Form Number: 160.81-M1 (LS02)

LITERATURE SUPPLEMENT

Subject: YR Chillers CE Optiview Control Center – High Pressure Cutout

LD12291

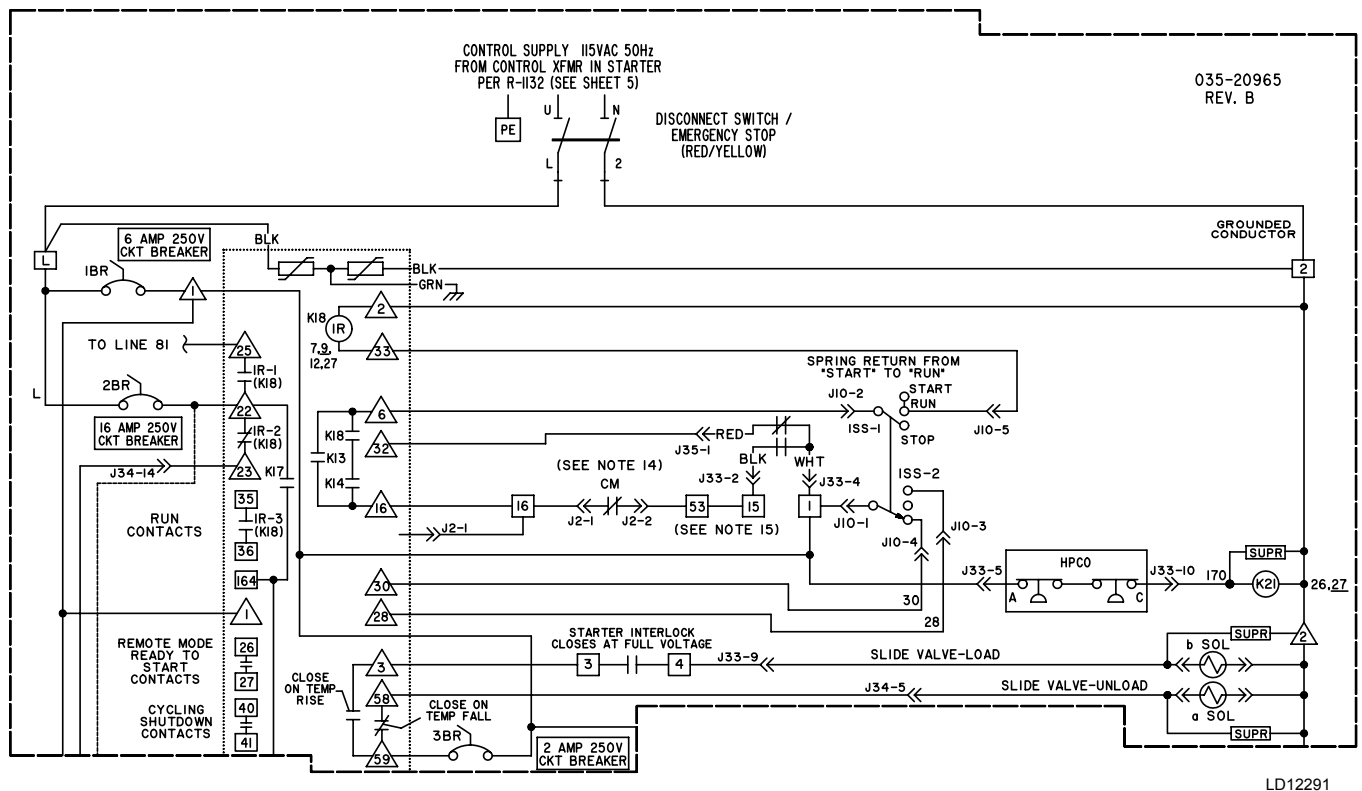
Beginning December 2006, new YR Chillers with CE Optiview Control Centers 371-04177-101/102 will be equipped with a dual High Pressure safety cutout (HPCO). This device requires the addition of a new relay, part number 024-30982-000. It is designated K21, as shown on wiring diagrams 160.81-PW8 (906) EM Starters) and 160.81-PW9 (906) (Solid State Starters).

Reference figure below. The HPCO contains dual series contacts. These contacts are in series with 115vac and the coil of K21, which is connected to neutral. The N.O. contacts of K21 are connected between TB6-1 and TB6-15. The N.C. contacts are connected between TB6-1 and TB3-32. Whenever power is applied to the Optiview Control Center and the HPCO contacts are closed, K21 is energized causing the TB6-1/TB6-15 circuit to be closed and the TB6-1/TB3-32 circuit to be open. If either of the HPCO contacts open, K21 de-energizes causing TB6-1/TB6-15 circuit to open (breaking the run signal to the motor starter) and TB6-1/TB3-32 circuit to close (signaling the microboard there is a HP fault).
